**UNITED STATES DEPARTMENT OF COMMERCE**  
**National Oceanic and Atmospheric Administration**  
NATIONAL MARINE FISHERIES SERVICE  
GREATER ATLANTIC REGIONAL FISHERIES OFFICE  
55 Great Republic Drive  
Gloucester, MA 01930-2276

**Re: Comments for the Bureau of Ocean Energy and Management's Draft  
Environmental Impact Statement for the Vineyard Wind Proposed Wind Energy  
Facility, Docket Number BOEM-2018-0069**

**ATTACHMENT A**  
**National Marine Fisheries Service's Comments on**  
**BOEM's Draft Environmental Impact Statement (DEIS) for the**  
**Vineyard Wind Offshore Wind Energy Project (BOEM 2018-0069)**

**Figure 1: VMS fishing effort (0-5kts) for Atlantic Mackerel, Squid, and Butterfish trip declarations, 2010-2018. The Vineyard Wind Lease Area is outlined in red.**

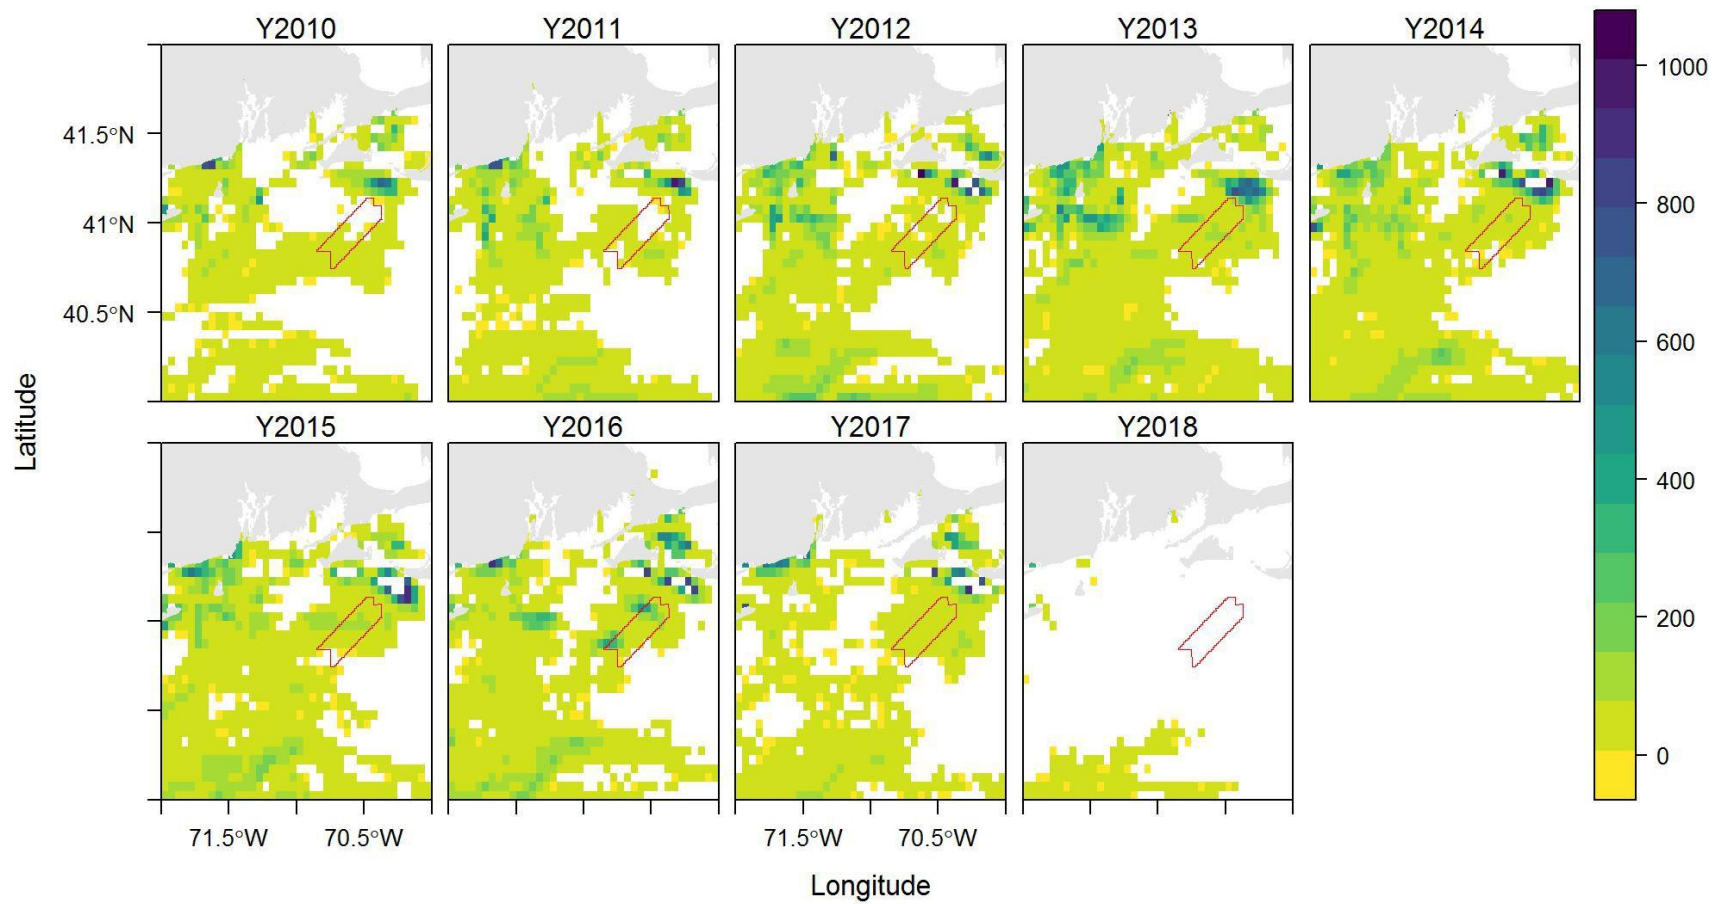
The Vineyard Wind EIS provided landings from 2011-2016, which are markedly different than those shown here.
